**STAFF RECOMMENDATION**  
**1720 Sweetbriar Avenue**  
**May 15, 2019**

**Application:** New Construction—Addition and Outbuilding  
**District:** Belmont-Hillsboro Neighborhood Conservation Zoning Overlay  
**Council District:** 18  
**Zoning:** RS7.5  
**Map and Parcel Number:** 11704000500  
**Applicant:** Anna Teeples  
**Project Lead:** Melissa Baldock, melissa.baldock@nashville.gov

<p><b>Description of Project:</b> The application is to construct a rear addition and a detached carport. The two structures will be less than twenty feet (20') apart.</p> <p><b>Recommendation Summary:</b> Staff recommends approval of the proposed addition and carport with the following conditions:</p> <ol style="list-style-type: none"><li>1. The siding have a maximum reveal of five inches (5");</li><li>2. Staff approve all window and door selections prior to purchase and installation;</li><li>3. Staff approve the material and color of the carport's roof;</li><li>4. The HVAC and utility connections be located on the rear or behind the midpoint of a non-street facing elevation.</li></ol> <p>With these conditions, staff finds that the proposed addition meets Sections II.B.1. and II.B.2. of the Bel

Figure 3. The site plan showing that there is just 15' between the second story deck and the carport.

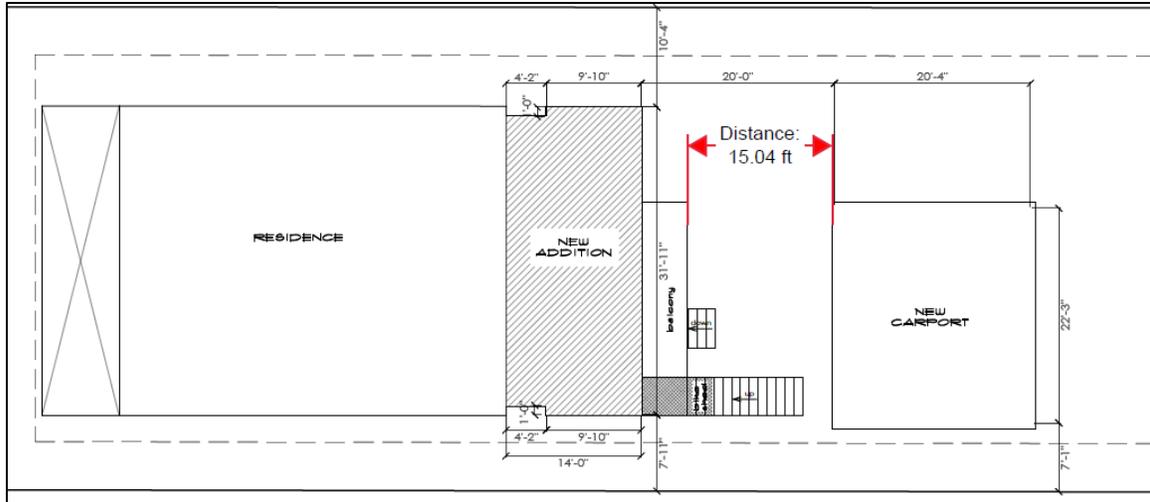
The proposed carport meets all base zoning setbacks. The design guidelines state that there should generally be a minimum of twenty feet (20') from the back of the house to any outbuilding. In this case, there is twenty feet (20') in between the back wall of the addition and the carport, but because of the second story-deck, there is just fifteen feet (15') between the back of the deck and the carport (Figure 3). Staff would typically count the back of the two-story deck as the back of the addition, and require twenty feet (20') of space between the back of the second-story deck and the carport. However, in this case, there is a substantial slope to the lot (Figure 4). From the front property line to the rear property line, there is a twenty foot (20') rise. The steep slope up makes construction at the rear of the lot more challenging. In addition, the existing carport that is to be demolished sits less than twenty feet (20') from the back of the house. Staff finds the proposed distance between the two structures to be appropriate for this lot.

sheet title:  
**A3.2** elevation

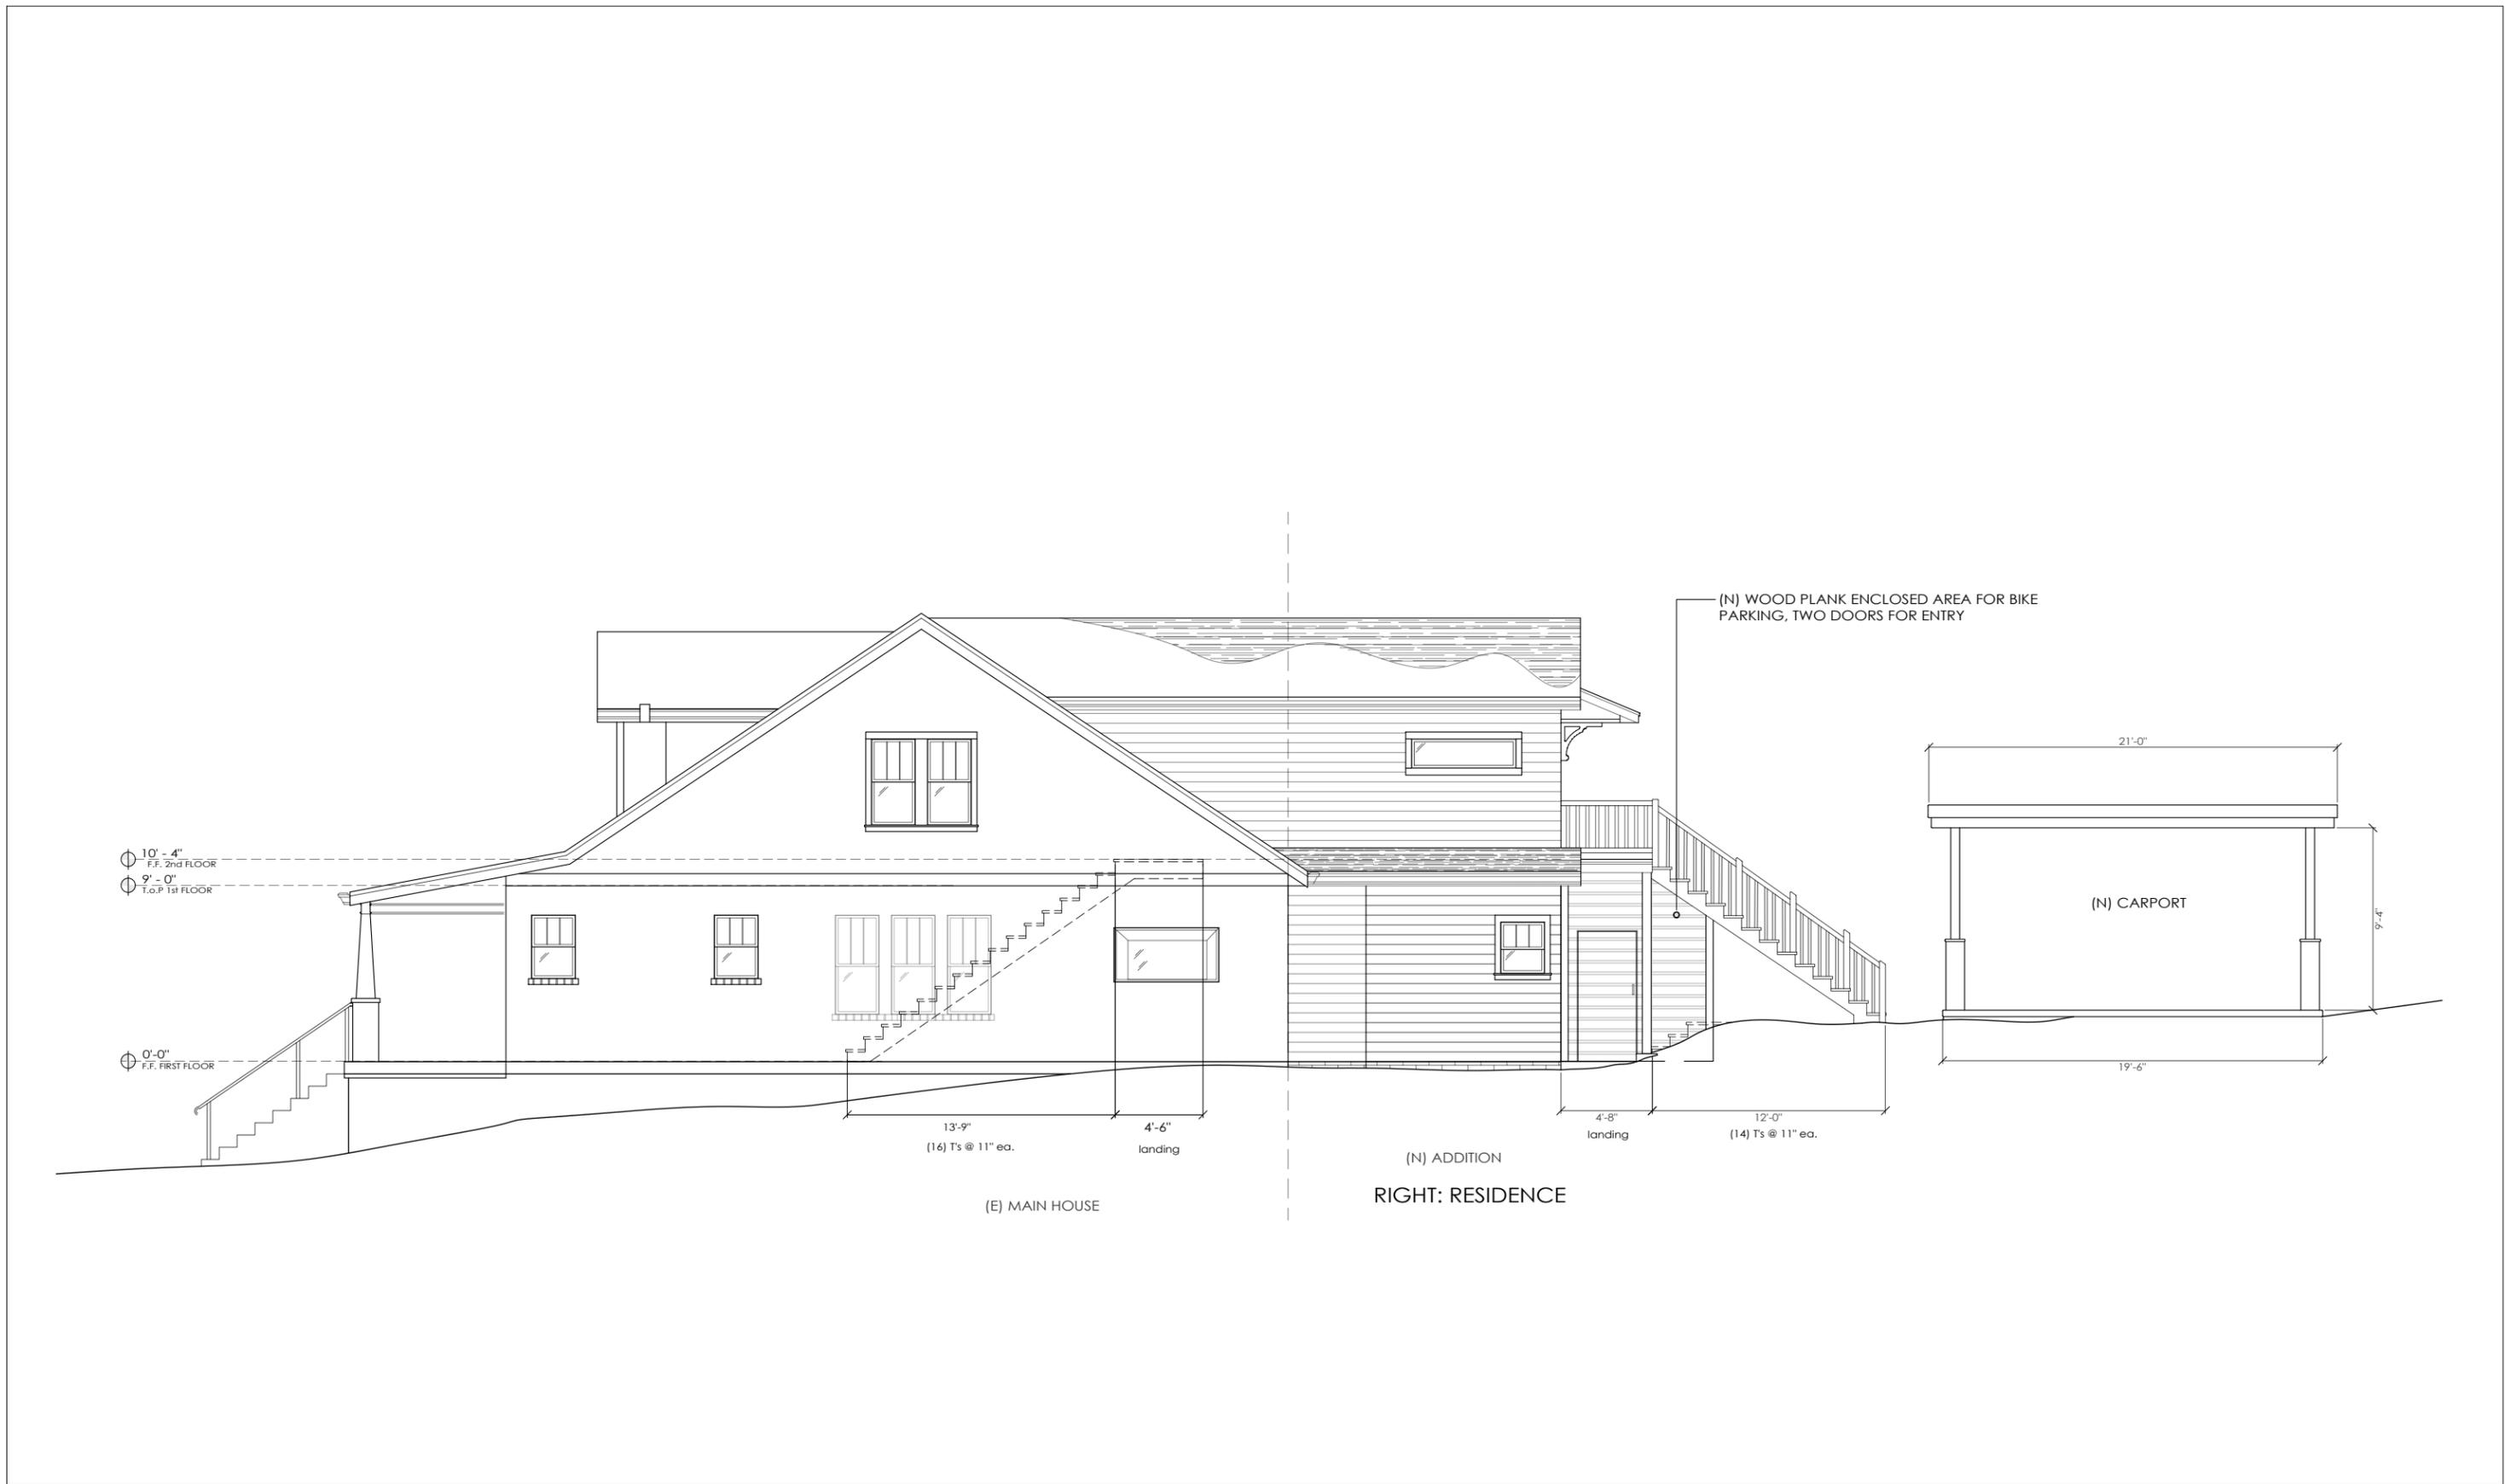
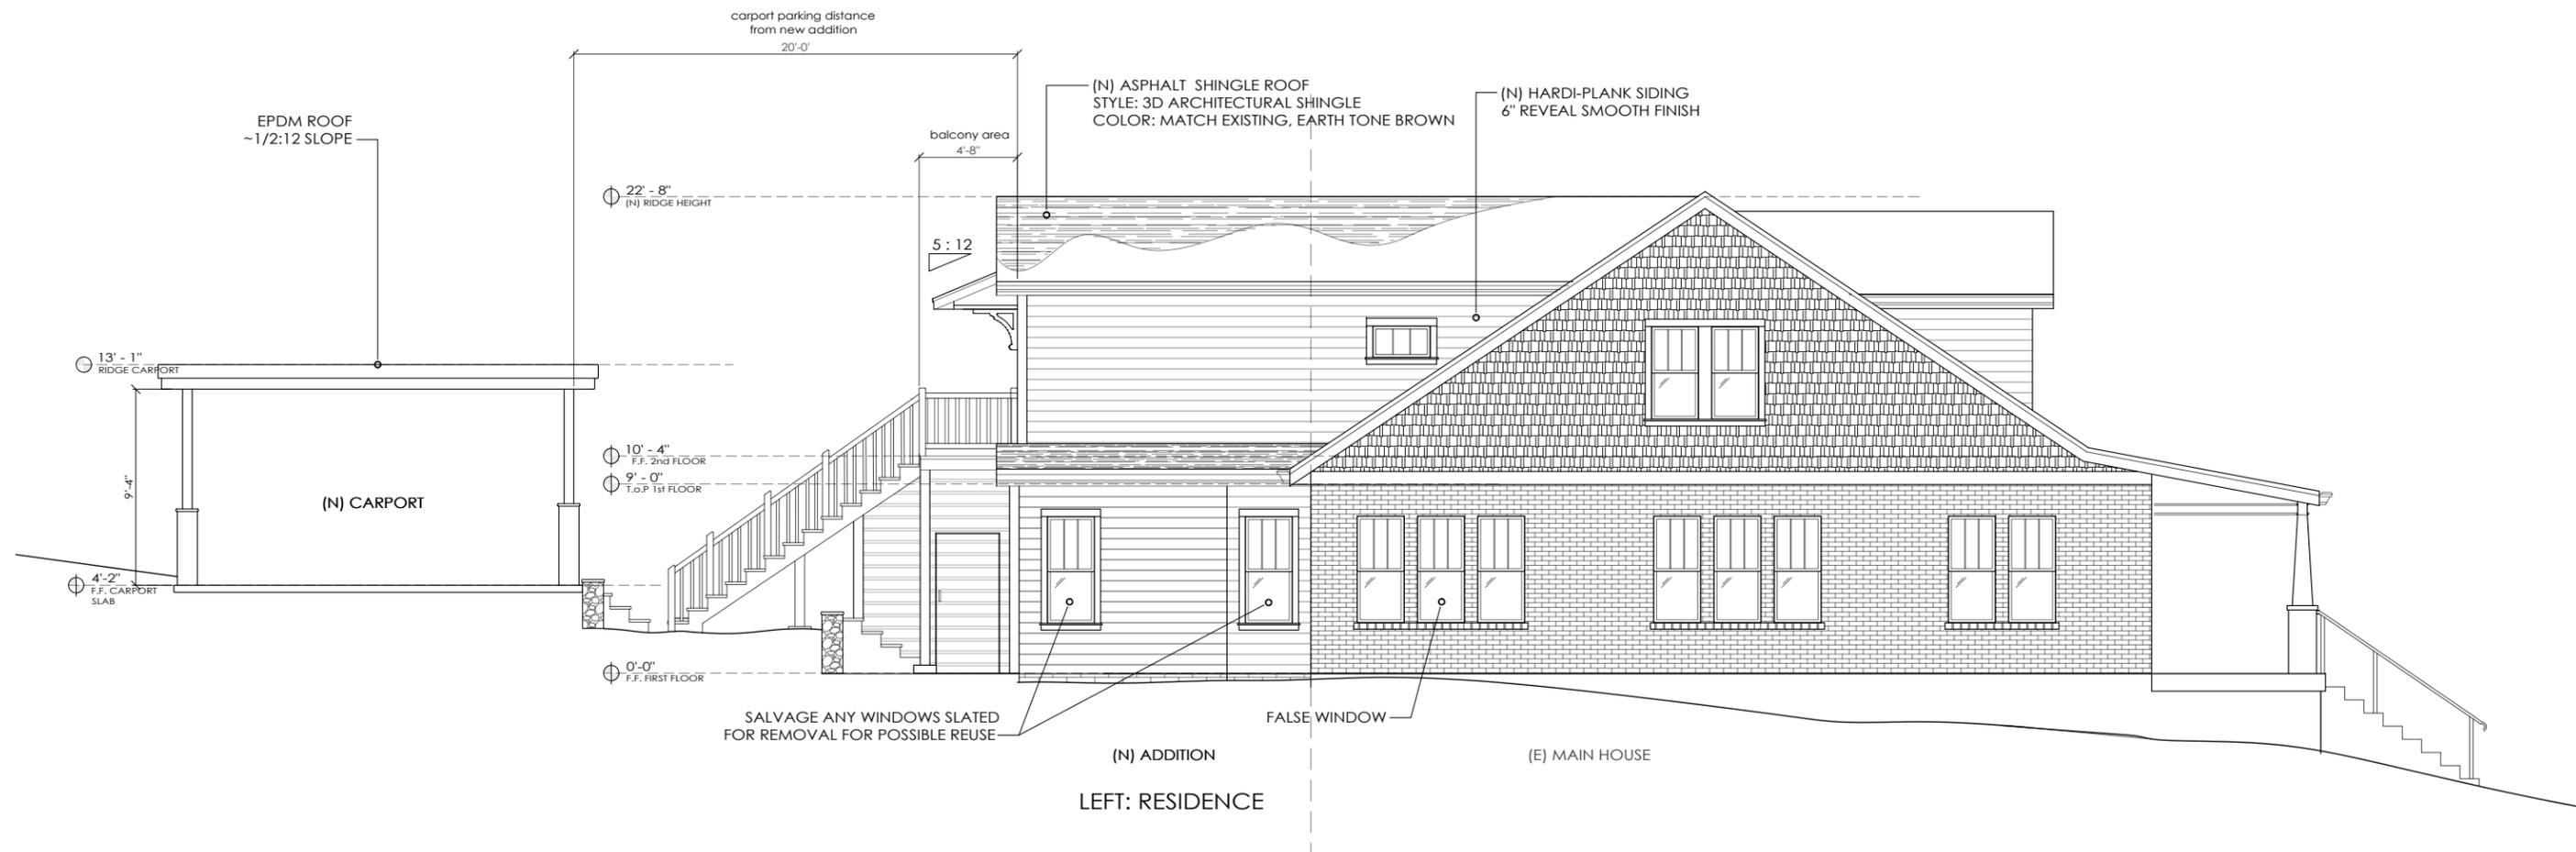
\*The drawings indicate lap siding with a six inch (6") reveal. The design guidelines limit the maximum lap siding reveal to five inches (5"). Staff therefore recommends that the siding reveal be five inches (5") or less.

Roof form: The historic house has a side gable roof form with a 9/12 pitch. The proposed addition will have a gabled roof with a 3/12 pitch. The design guidelines stated that roof forms should have at least a 6/12 pitch. However, staff finds the proposed lower pitch to be appropriate, in this instance, because the addition's upper floor is inset a full two feet (2') reducing the addition's visibility from the street. The addition also includes a second-story deck that creates a covered area below it.

Proportion and Rhythm of Openings: No changes to the window or door openings on the historic house were indicated on the plans. The windows on the addition are generally twice as tall as they are wide, with the exception of some horizontal windows on the second story. Since the windows will be inset two feet (2') from the historic house, they will not be highly visible and are acceptable. There are no large expanses of wall space without a window or door opening.

1. The siding have a maximum reveal of five inches (5”);
2. Staff approve all window and door selections prior to purchase and installation;
3. Staff approve the material and color of the carport’s roof; and
4. The HVAC and utility connections be located on the rear or behind the midpoint of a non-street facing elevation.
